MINERALS PROGRAM INSPECTION REPORT PHONE: (303) 866-3567

MINE NAME:		MINE/PROSPECTING ID#:	MINERAL:	COUNTY:
RBK Pit No. 30		M-1990-106	Gravel	Pueblo
INSPECTION TYPE:		INSPECTOR(S):	INSP. DATE:	INSP. TIME:
Monitoring		Elliott Russell	September 6, 2018	08:30
OPERATOR:		OPERATOR REPRESENTATIVE:	TYPE OF OPERATION:	
RBK Construction, Inc.		David King	110c - Construction Limited Impact	
REASON FOR INSPECTION:		BOND CALCULATION TYPE:	BOND AMOUNT:	
Normal I&E Program		Partial Bond	\$14,530.00	
DATE OF COMPLAINT:		POST INSP. CONTACTS:	JOINT INSP. AGENCY:	
NA		None	None	
WEATHER:	INSPECTOR'S SIGNATURE:		SIGNATURE DATE:	
Cloudy	At Bull		December 23, 2019

Photo 1. Mine identification sign; looking west.

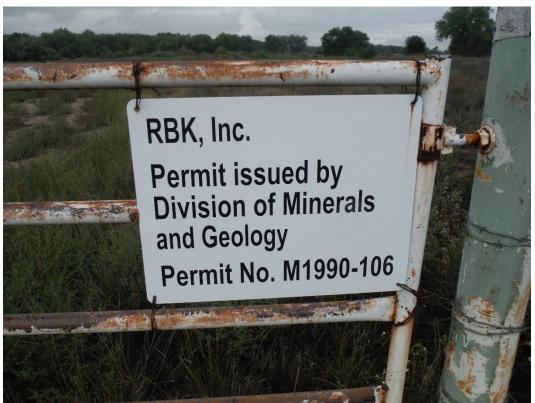
<u>Signs and Markers</u>: The permit sign was properly posted and boundary markers were observed to delineate the permit boundary.
